**PG&E Topock
Compressor Station
Needles, California**

**Revised Groundwater Corrective Measures
Implementation/Remedial Design Work Plan
for SWMU 1/AOC 1 and AOC 10**

November 2011

Subject: Revised Groundwater Corrective Measure Implementation/Remedial Design Work Plan for SWMU 1/AOC 1 and AOC 10, PG&E Topock Compressor Station, Needles, California (Document ID: PGE20111104A)

FIGURE 2-5
CONCEPTUAL REMEDIAL WASTEWATER TREATMENT
SCHEMATIC DIAGRAM
 CORRECTIVE MEASURES IMPLEMENTATION / REMEDIAL DESIGN WORK PLAN
 PG&E TOPOCK COMPRESSOR STATION
 NEEDLES, CALIFORNIA

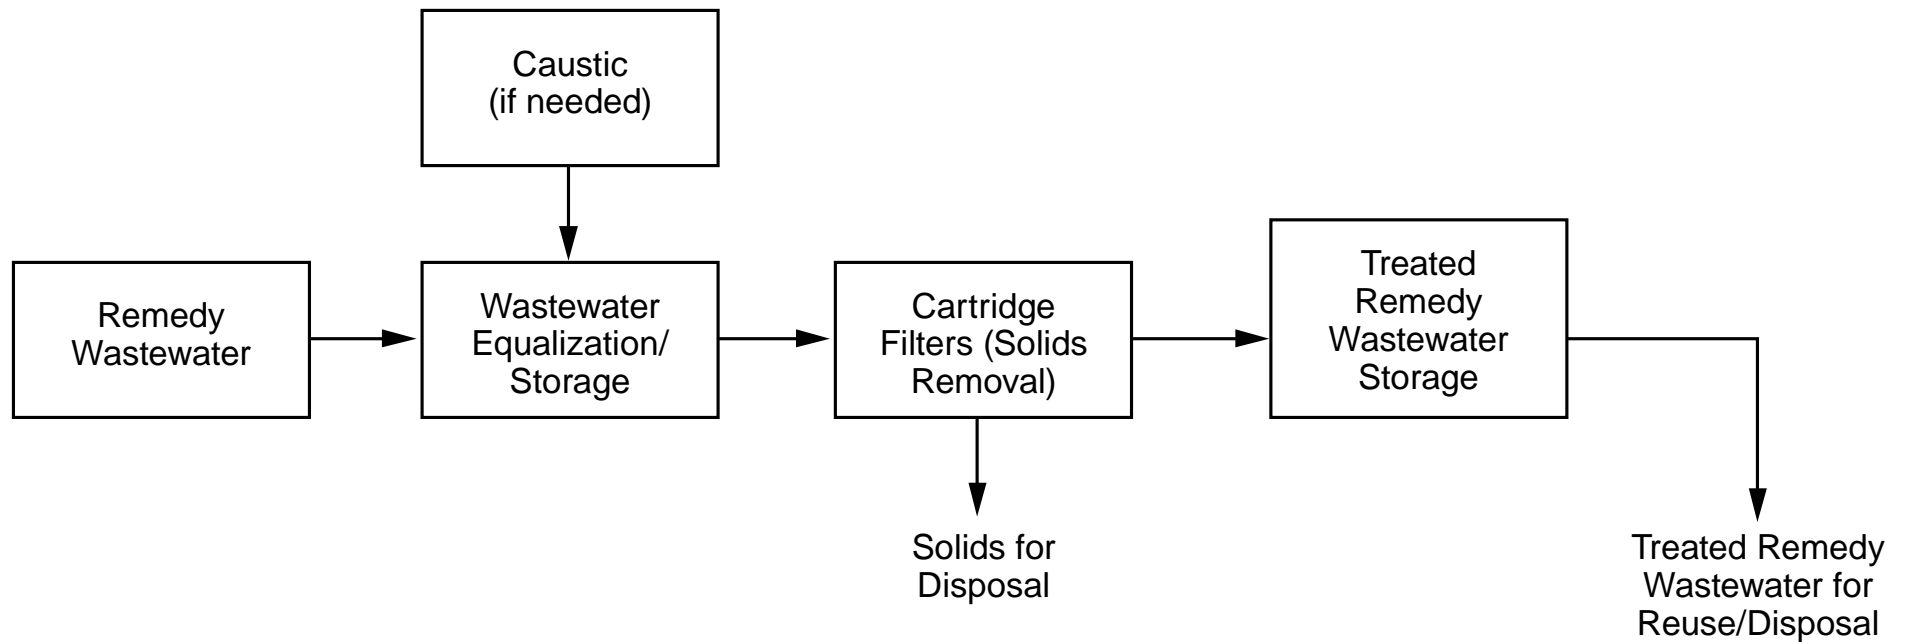
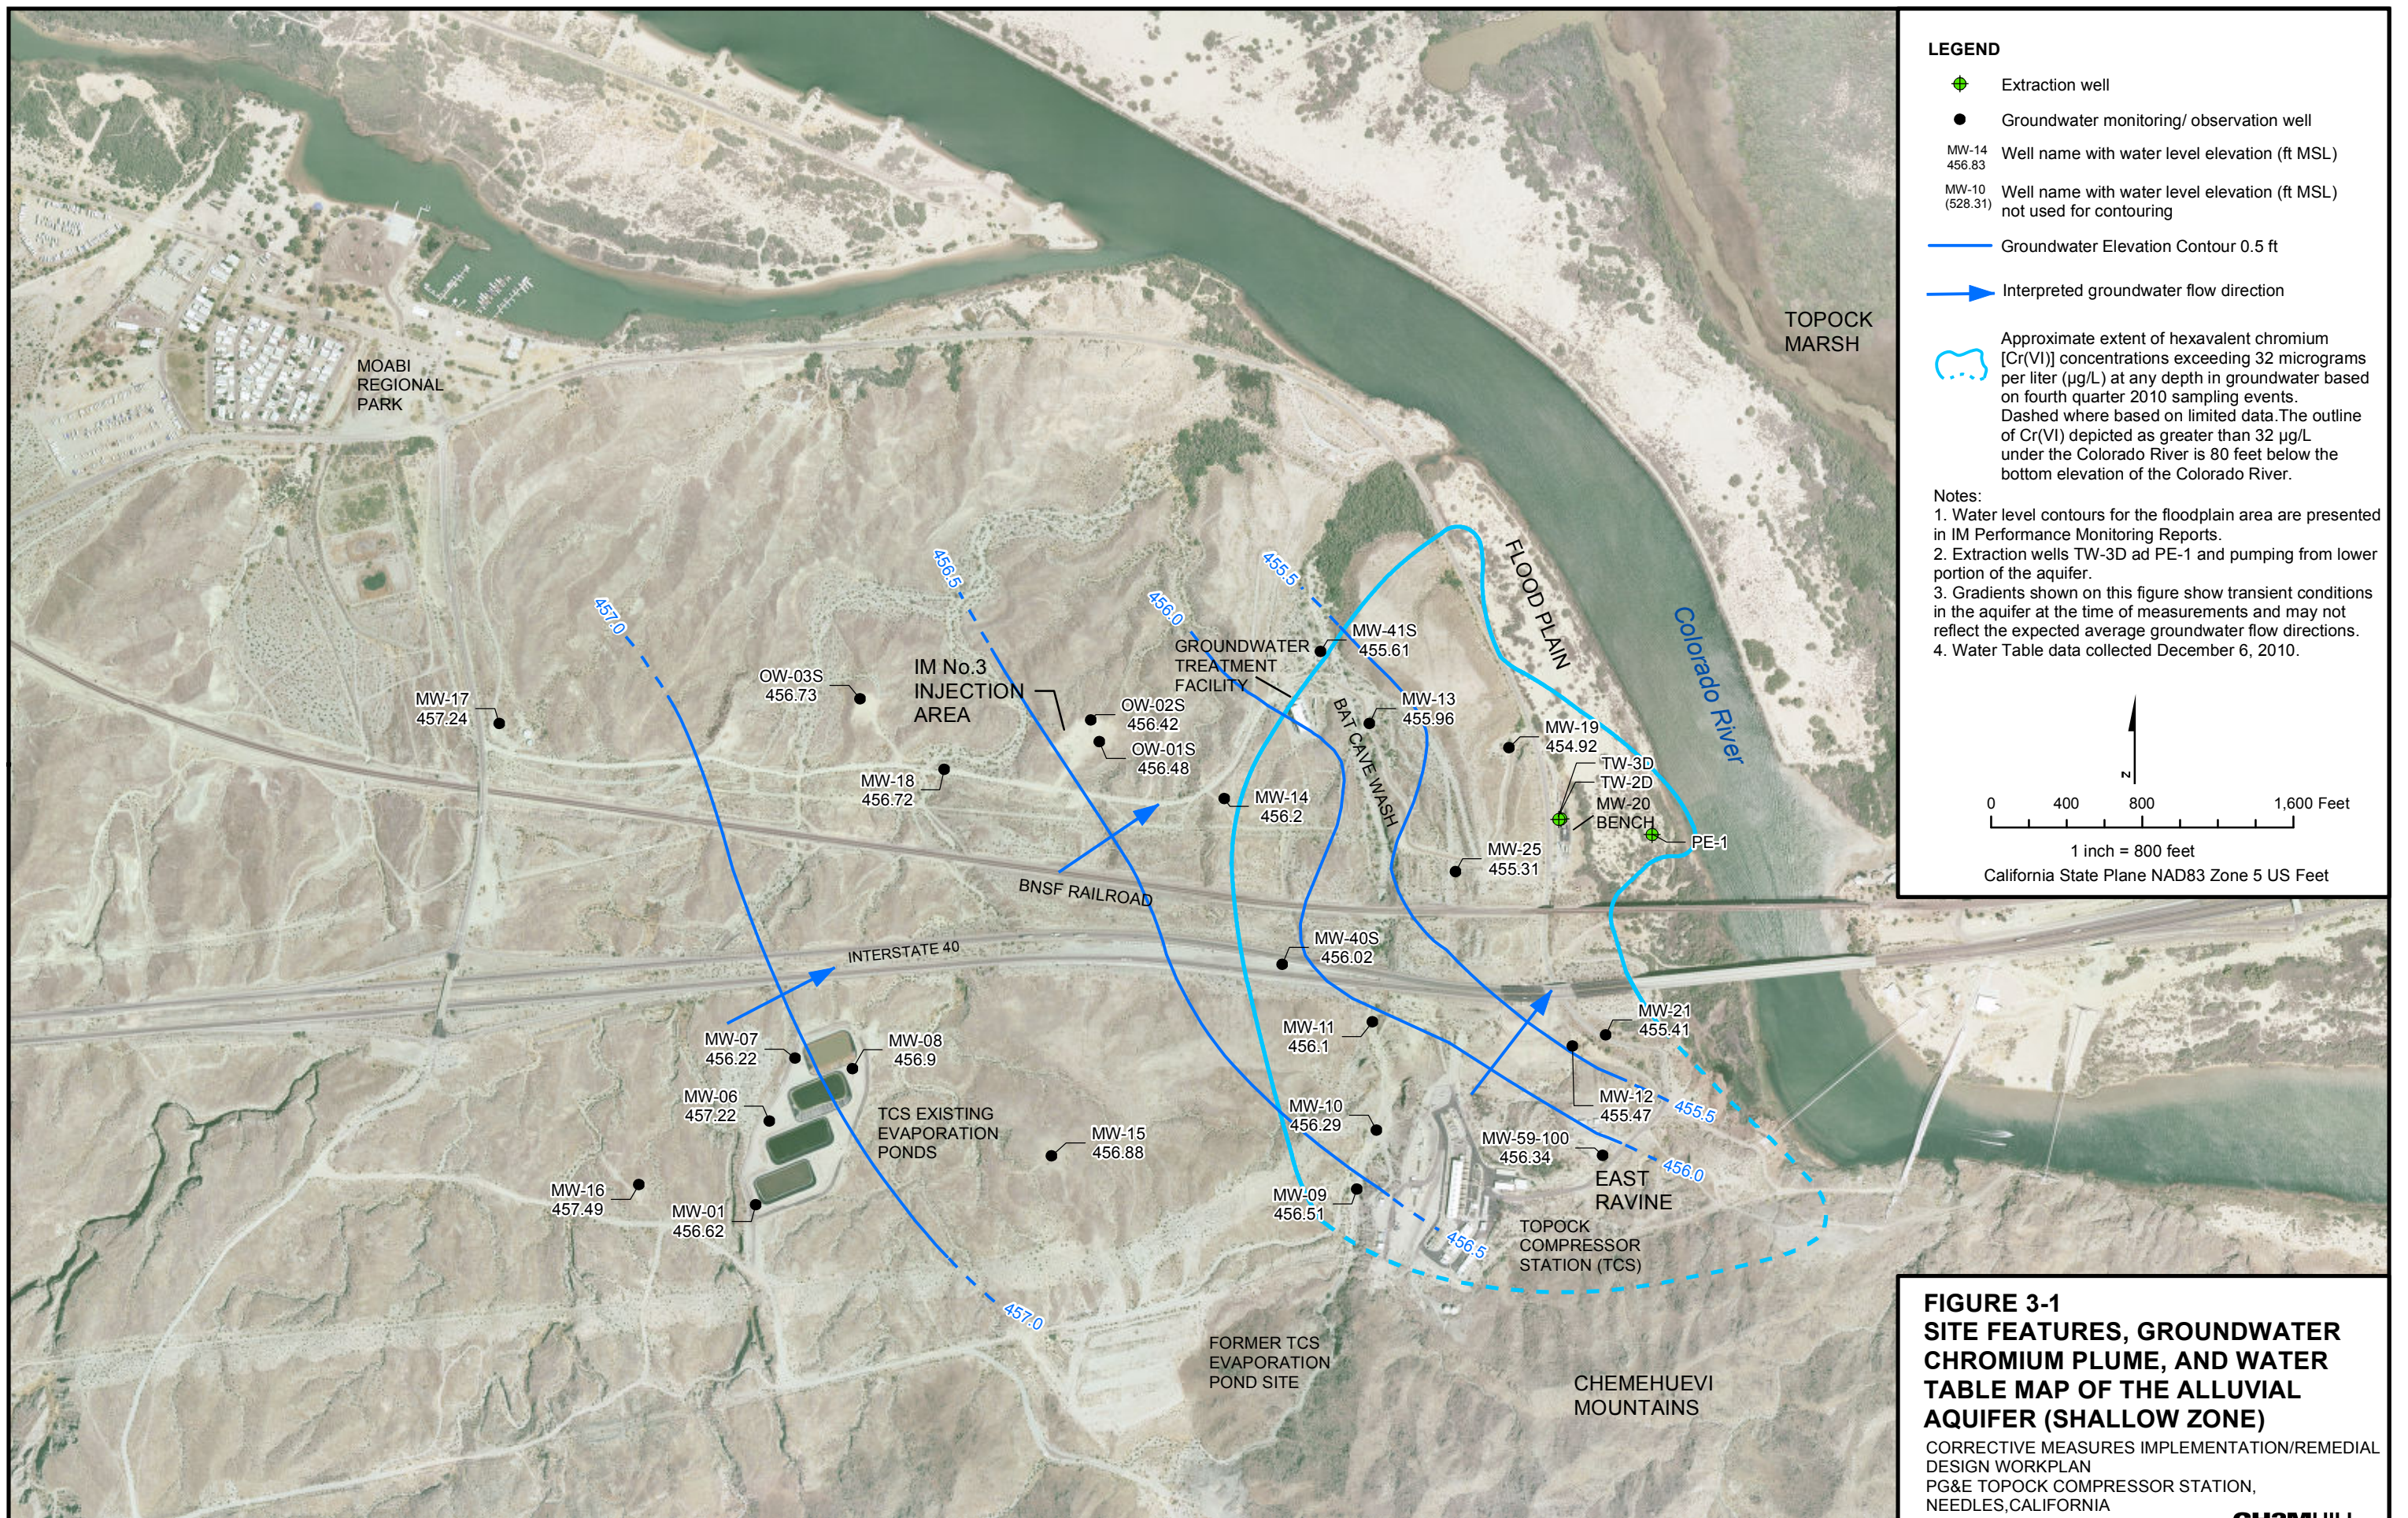
Comment Number	Section/Page	Reference Text	Commenter	Comment	PG&E Response	DTSC Response	DOI Response	Final Comment Resolution
	234	DOI-31	Figure 2-3						
				U.S. Department of the Interior	The diagram has two "neutralization" steps. Provide additional information regarding the process occurring in these steps.	Figure 2-3 will be revised.	Okay.	DOI looks forward to the opportunity to review the wastewater technical memorandum.	Comment resolution deferred to 30% design

FIGURE 3-1
SITE FEATURES, GROUNDWATER CHROMIUM PLUME, AND WATER TABLE MAP OF THE ALLUVIAL AQUIFER (SHALLOW ZONE)
 CORRECTIVE MEASURES IMPLEMENTATION/REMEDIAL DESIGN WORKPLAN
 PG&E TOPOCK COMPRESSOR STATION, NEEDLES, CALIFORNIA

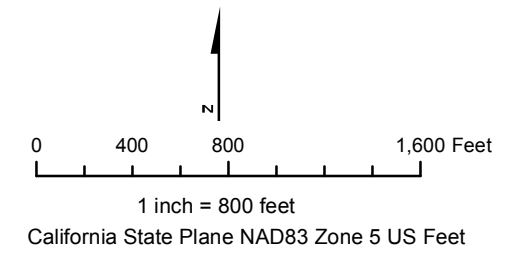
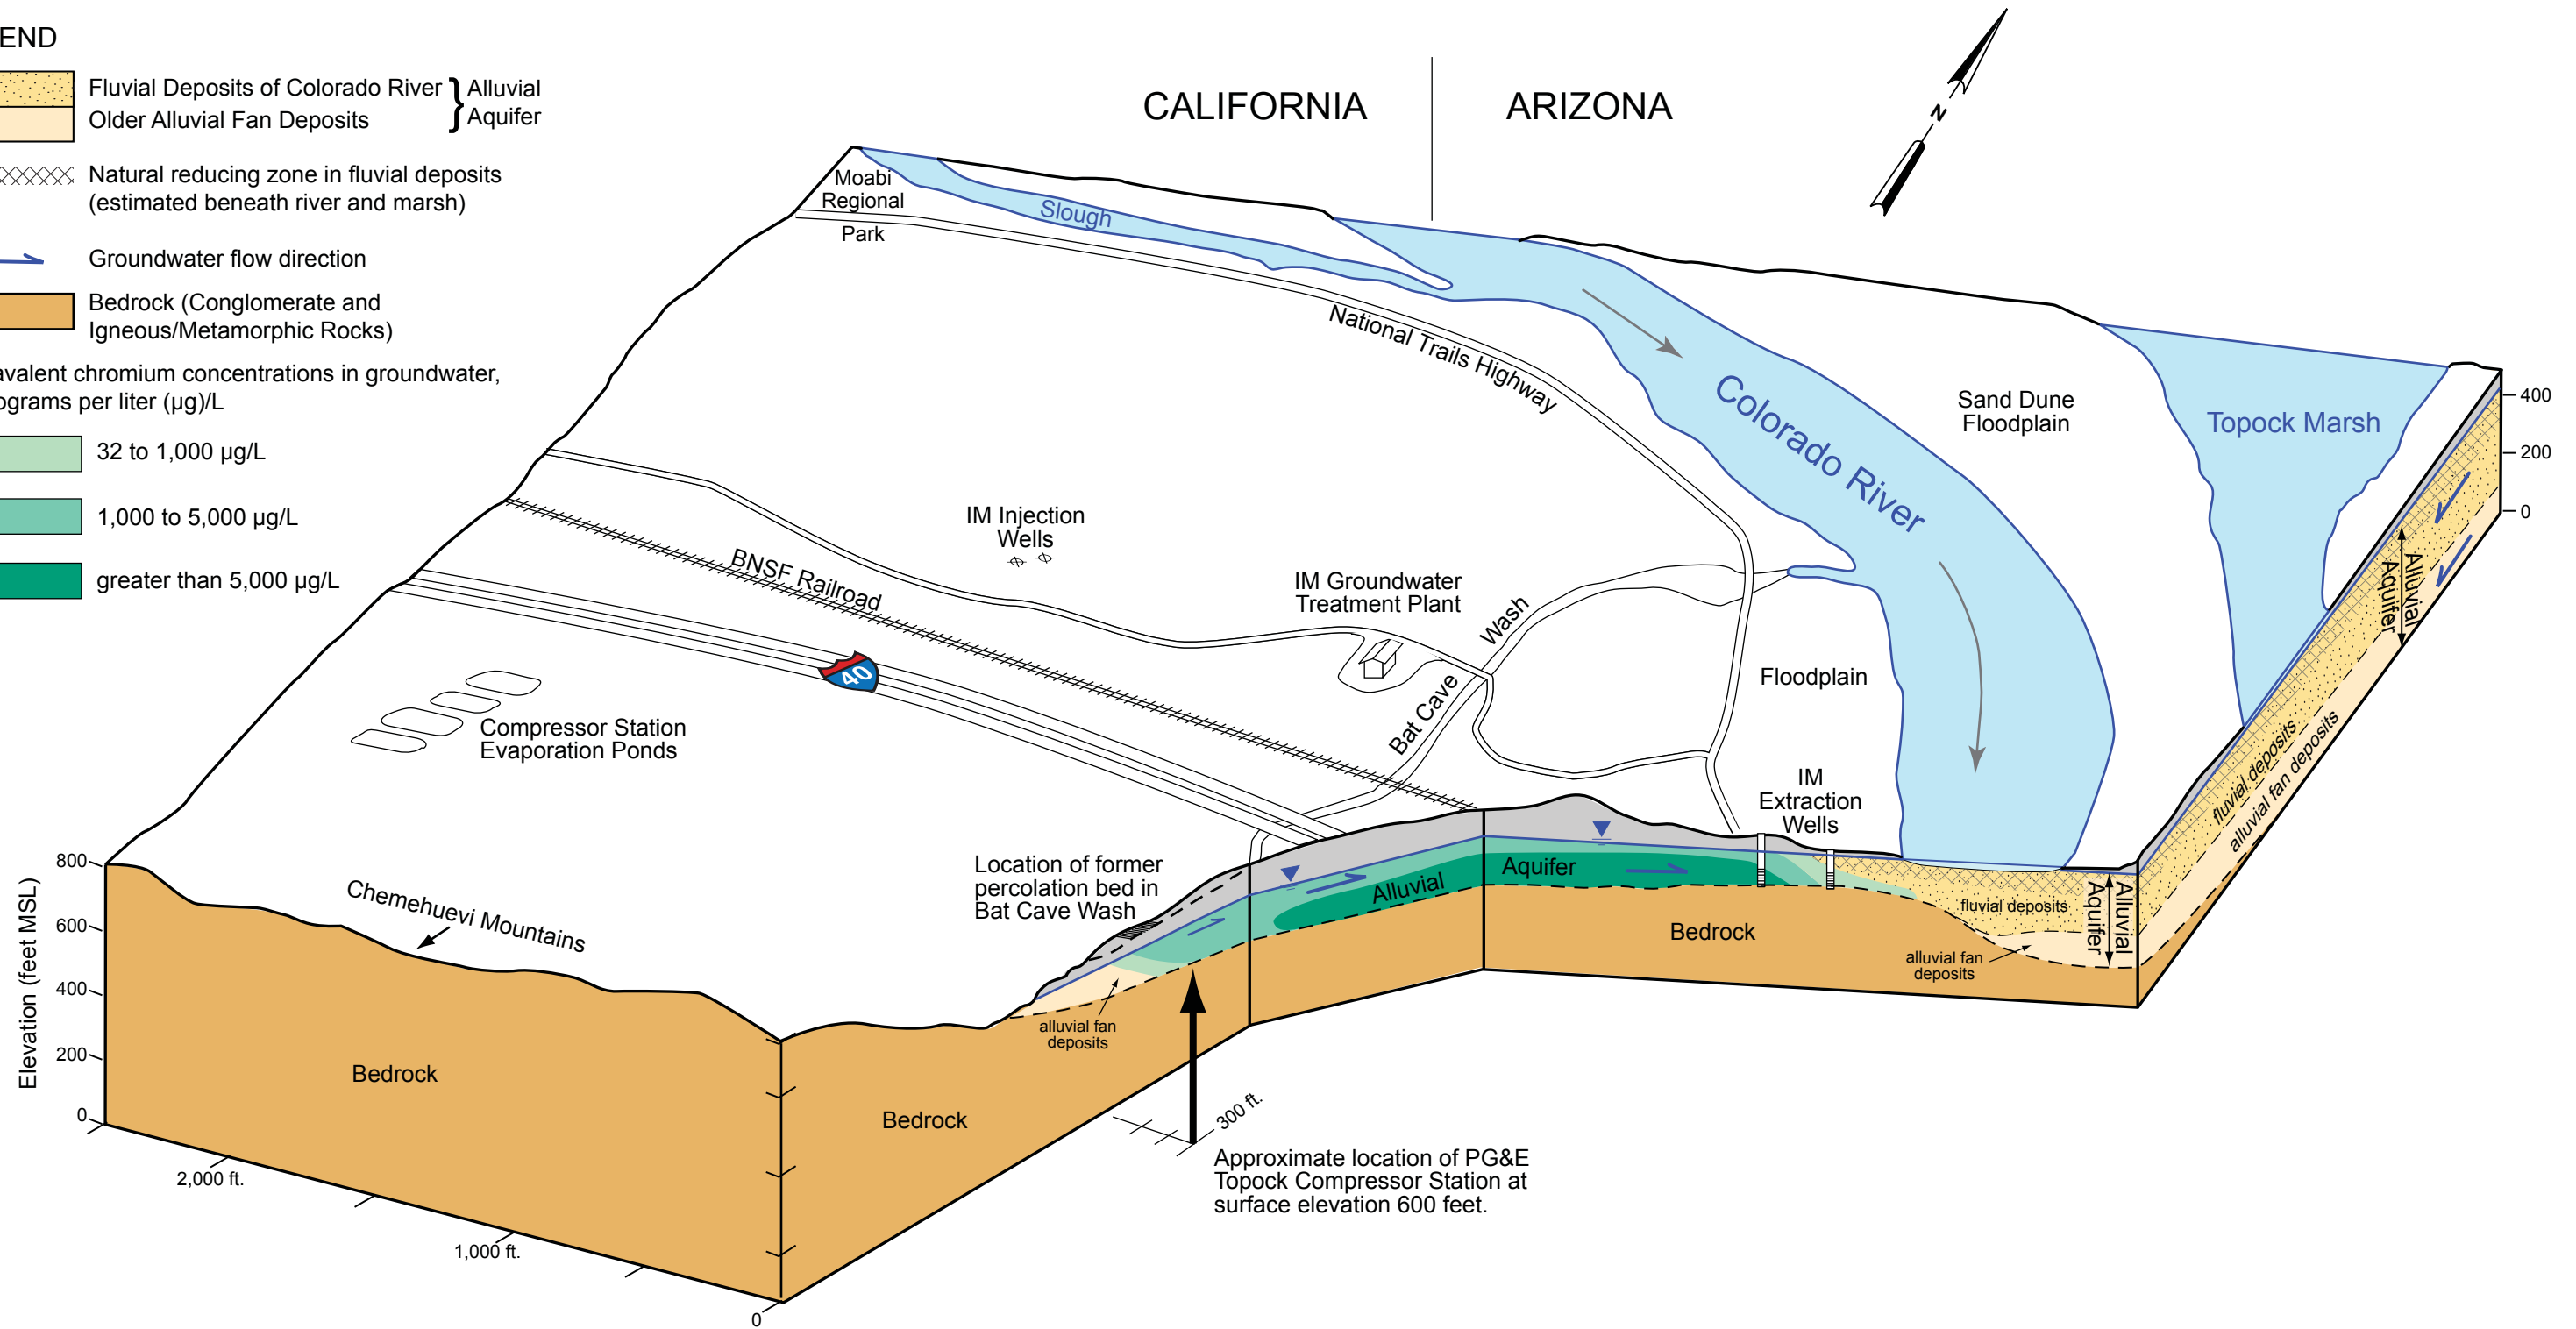
Comment Number	Section/Page	Reference Text	Commenter	Comment	PG&E Response	DTSC Response	DOI Response	Final Comment Resolution
130	DOI-32	Section 3.1.1, page 3-2, 1 st para.		U.S. Department of the Interior	Figure 3-1 should show the potentiometric surface with arrows to denote groundwater flow direction to support the text discussion.	Revised Figure 3-1 is attached to these responses.	Okay	DOI concurs with the response.	Comment resolved.
131	DOI-33	Section 3.1.1, page 3-2		U.S. Department of the Interior	The phrase "significant quantities of groundwater" may not be appropriate in this context. Typically, that phrase relates to "significance" as a groundwater supply. Bedrock may in fact be a significant contaminant transport pathway, especially in the East Ravine. DOI suggests deletion of this last portion of the sentence	The discussion in Section 3.1.1 relates to the regional properties of the bedrock in Mohave Valley. The sentence in question is paraphrased from "Geohydrology of the Needles Area, Arizona, California, and Nevada" (Metzger and Loeltz, 1973). The reference states: "There is no evidence to indicate any sizable potential for development of ground water in the bedrock, although locally, small yields may be developed from fractures". The actual sentence from the reference will be inserted in place of the paraphrased sentence and a citation to the reference will be provided.	Okay	DOI concurs with the response.	Comment resolved.
